TECHNICAL STAFF REPORT

Case No./Petitioner: SDP-17-042, Howard Research and Development Company

Project Name: Downtown Columbia, Crescent Neighborhood, Parcel B

Request: To approve a long-term, but temporary, 181 space surface parking lot to serve

COVER SHEET G. L. W. FILE No. SCALE **ZONING** DOWNTOWN COLUMBIA NT 15019 AS SHOWN TAX MAP - GRID SHEET DATE (PART OF TAX PARCEL 527) PLAT NO. 36 - 01 1 OF 10 MAY, 2017

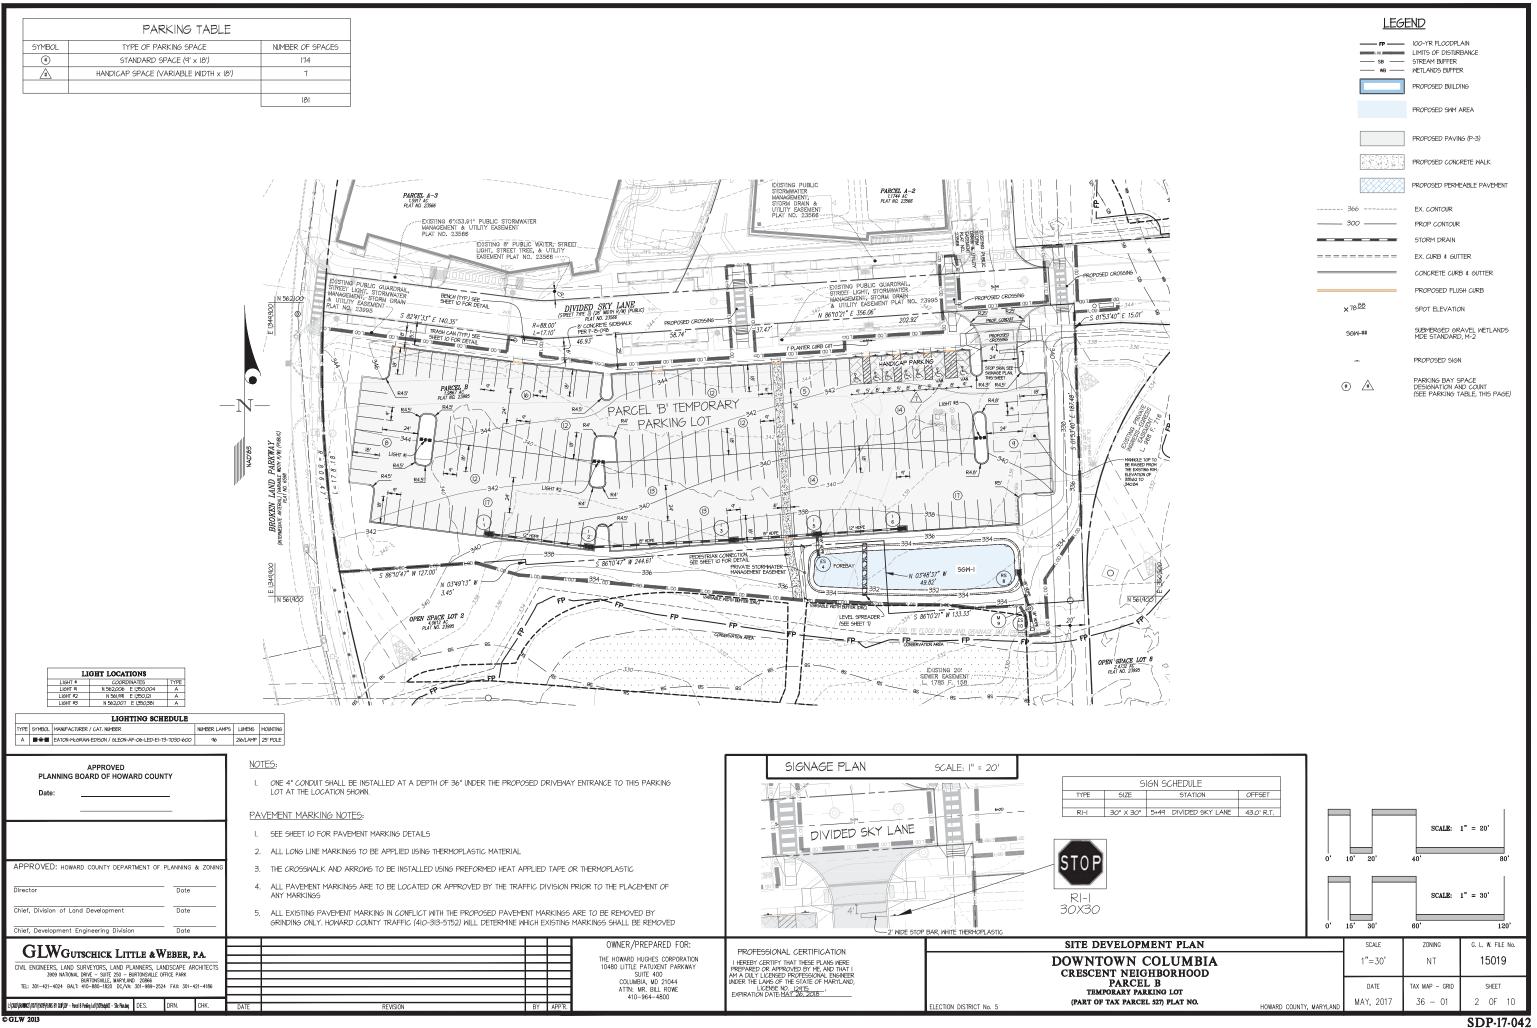
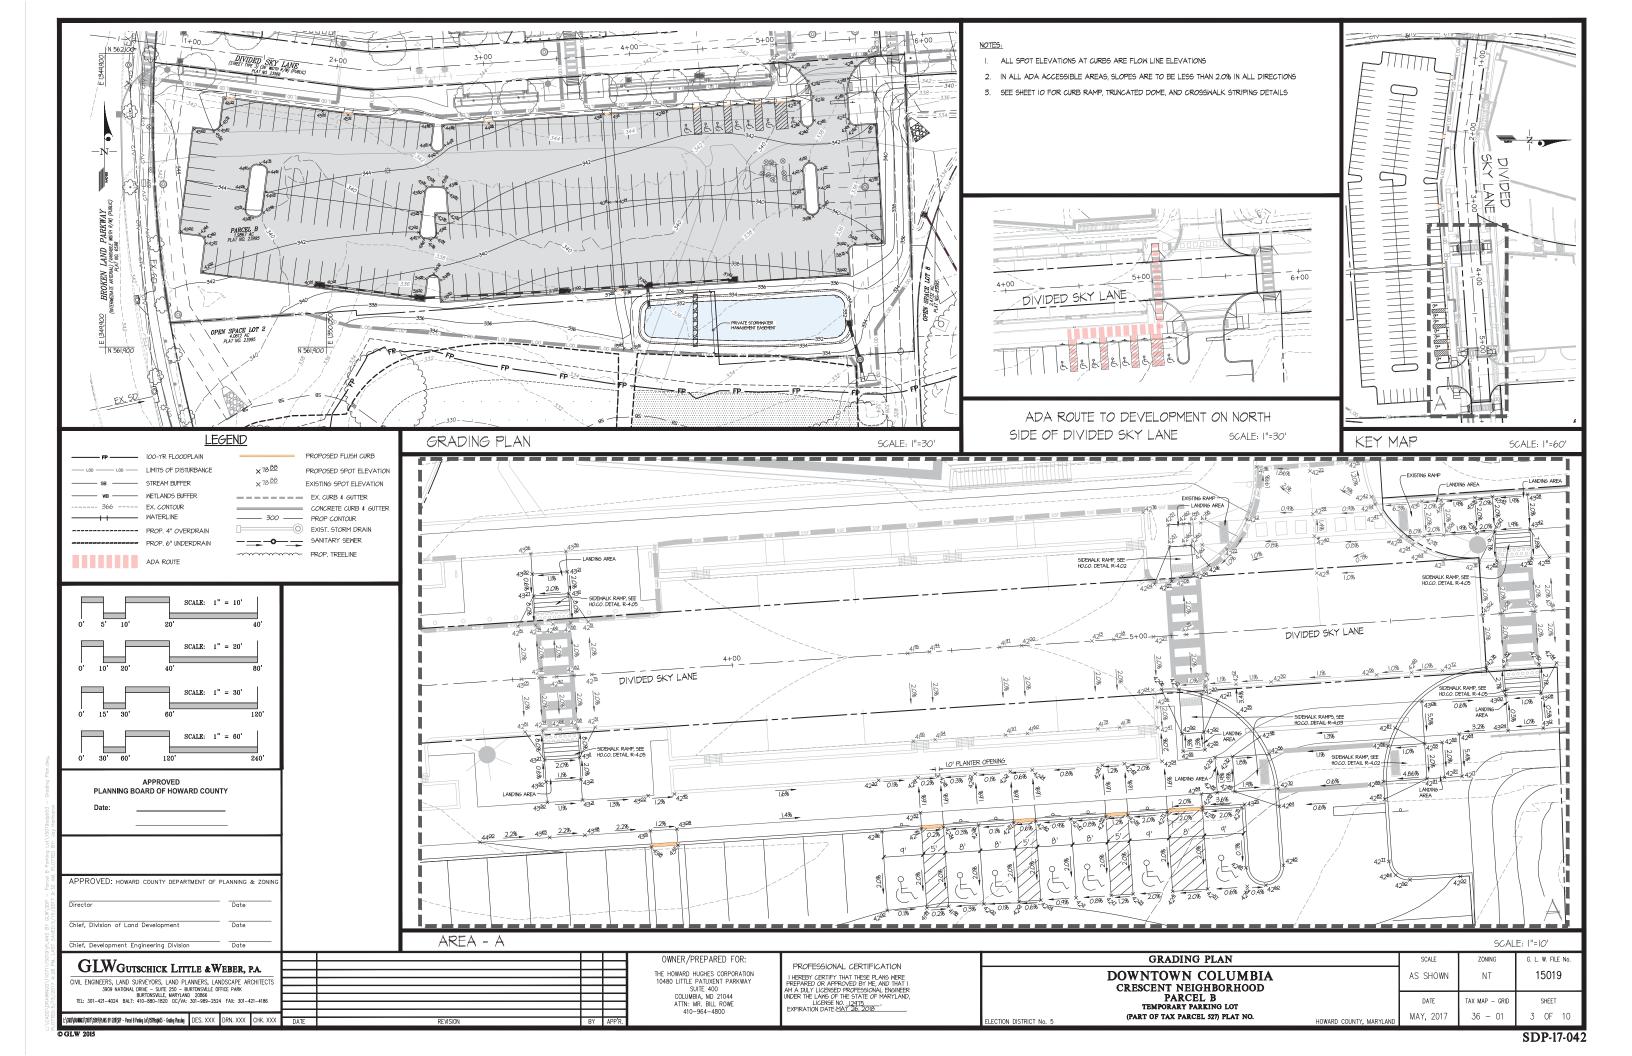
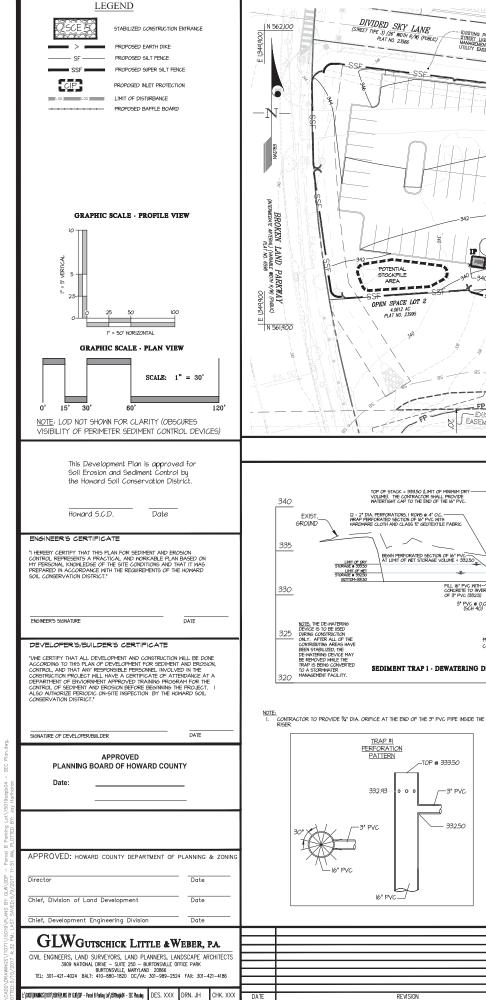
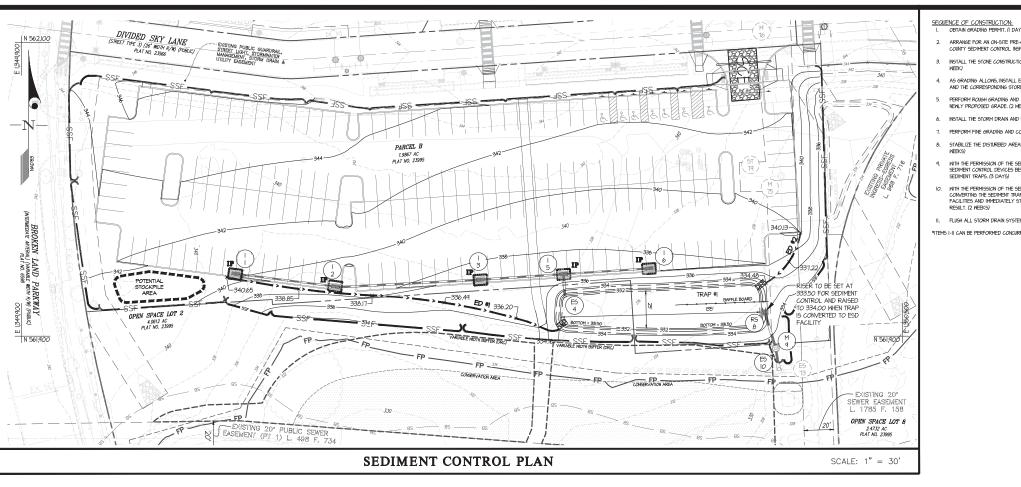
building, it should be noted on the plan.	
Sheet_01.pdf	DLD_Jill	Planning Board Approval is required.	06/02/2017
Sheet_01.pdf	DLD_Jill	Add the plat number on the Permit Block.	06/02/2017

Sheet_01.pdf	DLD_Jill	At least one tree was requested along the rear perimeter	06/02/2017
Sneet_v1.pui	טבט_יווו	to shade the expanse of pavement along that edge (2-3 preferred along that entire pavement edge). Please adjust surety to accomodate any additional trees.	00,02,2017
Sheet_01.pdf	DLD_Jill	O's Only Plat for private SWM easements on OS Lot 2 must be recorded prior to signature approval of the SDP.	06/02/2017
Sheet_10.pdf	bmuldoon	Curb ramp standard specifications from the Howard County Design Manual should be perpendicular or parallel (R-4.05 or R-4.06). Additional detail is available from the US Access Board (such as double perpendicular).	06/01/2017
Sheet_03.pdf	DLD_Jill	Please remove the old alignment linework over the driveway.	06/01/2017
Sheet_03.pdf	DLD_Jill	Even though the parking goes over the minimum required for this development, if the plan is providing additional parking to be used by a specific building, the entire ADA route should be shown. Confirm with DILP what is required.	06/01/2017
